Community and Planning Commission Questions + Requests  
 PCA and FDPA 2003-PR-022-02/CDPA 2003-PR-022  
 November 3, 2021 PC public hearing and letters submitted for the record

Retail

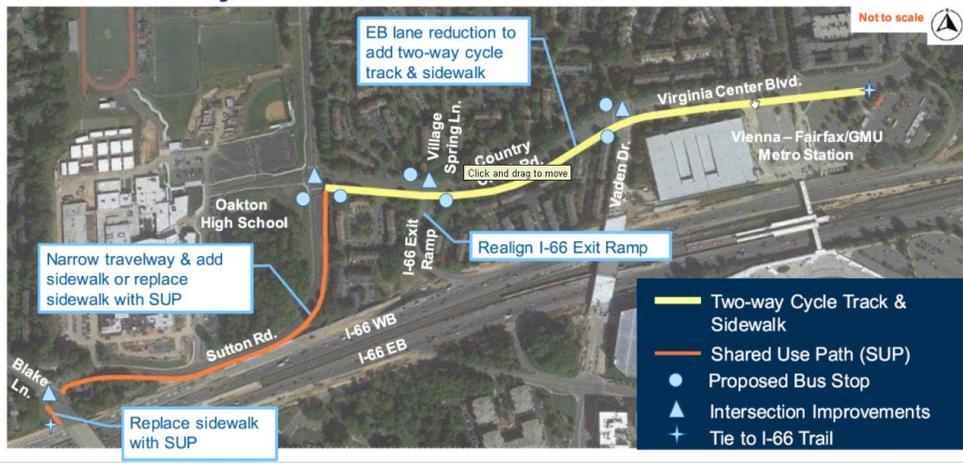
- a. Has Pulte considered even some small convenience retail or coffee shop? Some place to gather?

Yes, those types of uses are anticipated as part of the 35,000 square feet of ground floor uses within Pulte's PCA area as well as on the ground floor of the CRC portion of MetroWest. Extensive retail analyses were

commissioned by CRC and Pulte. Subsequent to approval of the rezoning in 2006, Tysons and Mosaic were approved have undergone massive redevelopment, and the Pam Am shopping center was renovated. The Applicant believes as the remainder of MetroWest is developed, a combination of local, regional, and national retailers will be more likely to establish a presence within MetroWest, creating the ambiance that the community is seeking.
